## **COUNCIL WORKSHOP AGENDA**

**WEDNESDAY 9 NOVEMBER 2011**

The purpose of this workshop is to discuss the Environment Court decision establishing the Living G Yaldhurst Zone and subsequent resource consents which sought to carry out a development different to those rules, particularly relating to the reduction of minimum size of some lots, reduction in the width of the spine road, and the relocation of cycleways.

**Noble Village - Yaldhurst Subdivision (RMA 92009135)  
Queue Space**

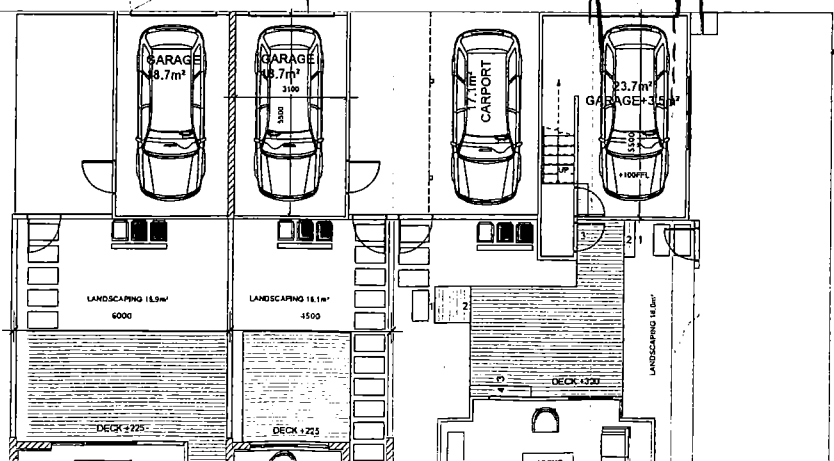
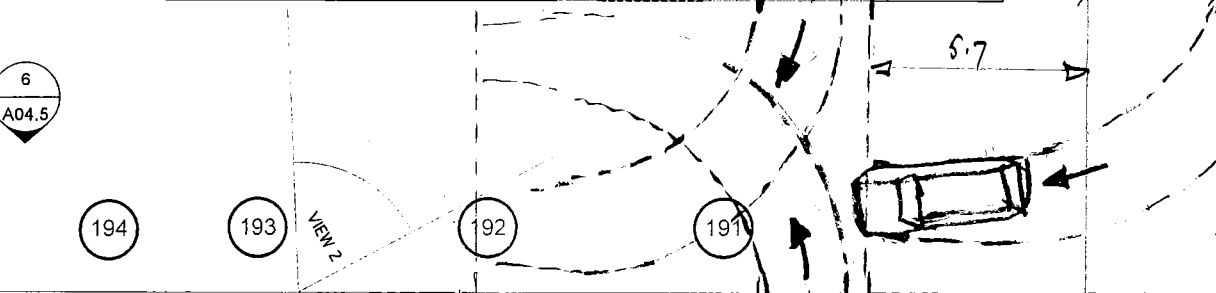
There are a number of rear lanes providing access to garages at the rear of properties within the Noble Village Development. The intersection which has the greatest potential conflicts arising, are vehicles right turning into ROW 703, which provides access to 17 lots, shown D on drawing PS-02. For the worst case scenario there is a safe waiting queue length for one large car after completion of a right turn into the right of way when a vehicle is reversing out of the closest garage. Car movements are annotated on attached part copy of plan A04.0 B.

It is agreed there is not enough queuing space for a second vehicle following the first through the same gap to wait and safely clear the oncoming traffic lane. The second driver of the vehicle following would be able to see the predicament and stop and give way until the situation cleared. (It is unlawful to proceed into an intersection until the way is clear.)

As the vehicles using the lanes are residents there is a heightened awareness for manoeuvres from the garages/ carports and therefore I believe the potential for conflicts in this situation is very low.

Mr Stokes is also concerned that vehicles from the lane will need to reverse out onto the spine road. The lane serves residential garages/ carports and therefore manoeuvres will take place into or out of the garage/ carport space which would allow a forward movement onto the spine route. If a non-resident vehicle does go into the lane by mistake the 8m width of lane does provide space for most vehicles to manoeuvre into a forward position to exit the lane. The urban design of the rear lanes as depicted on the applicant plans would discourage their use by non-residents therefore the scenario discussed would be rare.

**CONSTRUCTED SPINE ROAD  
NOT MEETING MINIMUM  
SAFETY STANDARDS  
OR RULES**

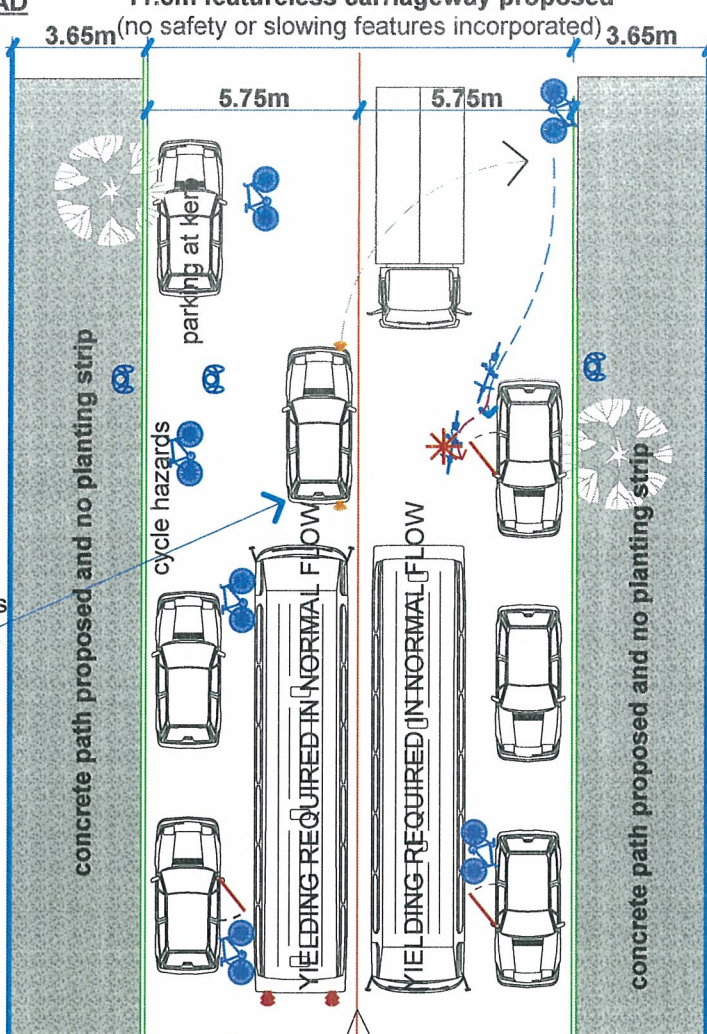
**COLLECTOR ROAD  
Peak 1500 VPH**

It is accepted by all traffic engineers that yielding will be required to accommodate normal traffic flows to prevent "squeezing". One of the applicant traffic reports states a centreline will not be marked so as to allow vehicles to "cross the centreline" of the collector road.

Two storey units built up to the road boundary without required 3m setback & required 2m landscaping

**ENVIRONMENT COURT  
& CITY PLAN RULES  
REQUIRED DESIGN  
and  
AS BUILT IN DELAMAIN**

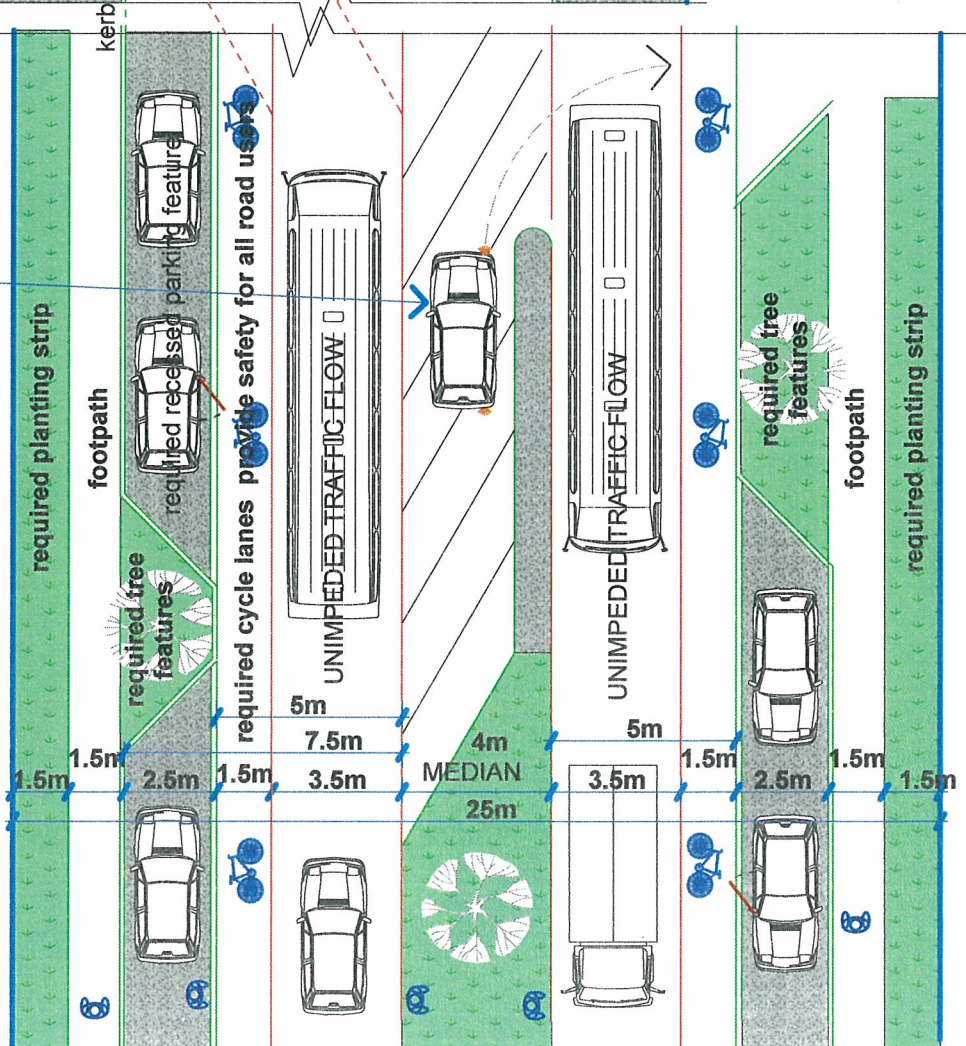
The centre median required is proposed to be deleted along with the cycle lanes and the land required by the City Plan Zone rules for these community amenities is proposed to be given to the developer for private profits

It is accepted by all traffic engineers that yielding will be required to accommodate normal traffic flows to prevent "squeezing". One of the applicant traffic reports states a centreline will not be marked so as to allow vehicles to "cross the centreline" of the road.

SECONDARY LOOP ROAD AS REQUIRED BY THE CITY PLAN AND AS BUILT THROUGH ENTERPRISE DEVELOPMENT

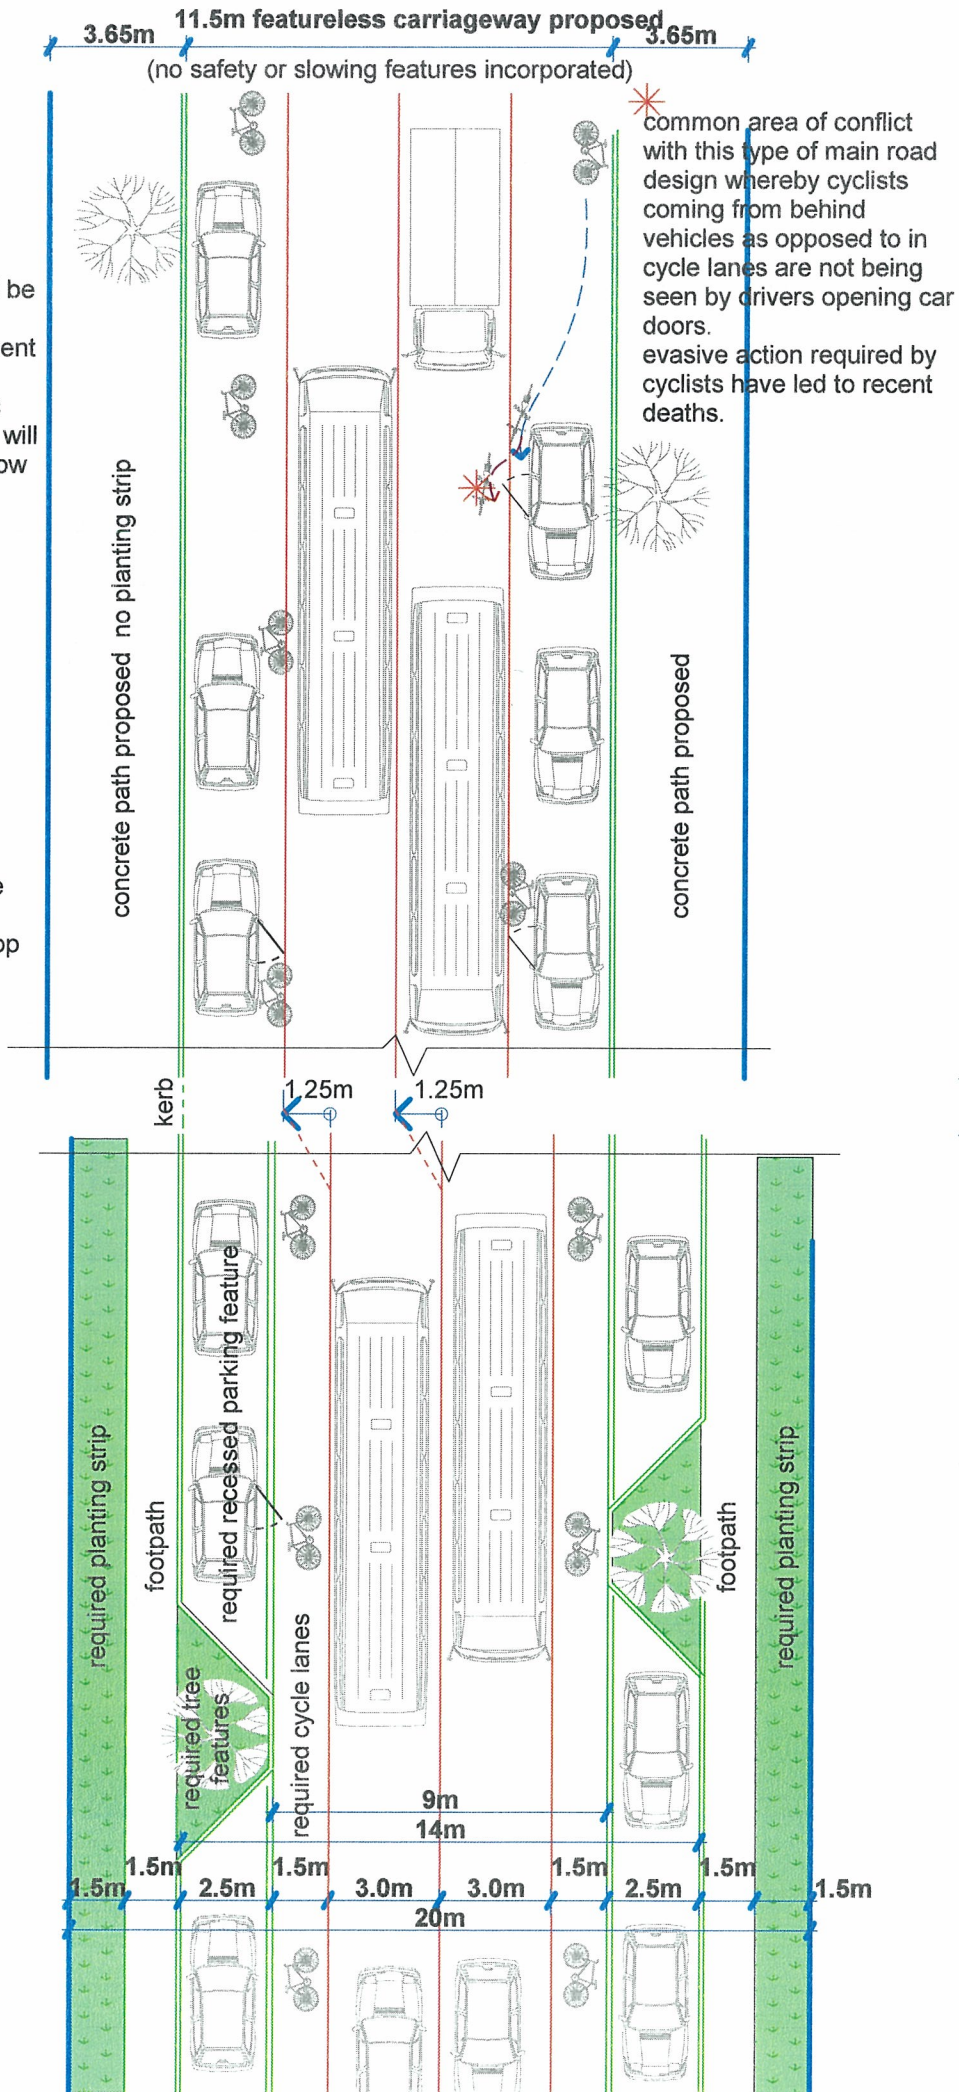
The required cycle lanes disappear when Enterprise Homes loop road connects with Noble Investments loop road

Common area of conflict with this type of main road design whereby cyclists coming from behind vehicles as opposed to in cycle lanes are not being seen by drivers opening car doors. Evasive action required by cyclists have led to recent deaths.
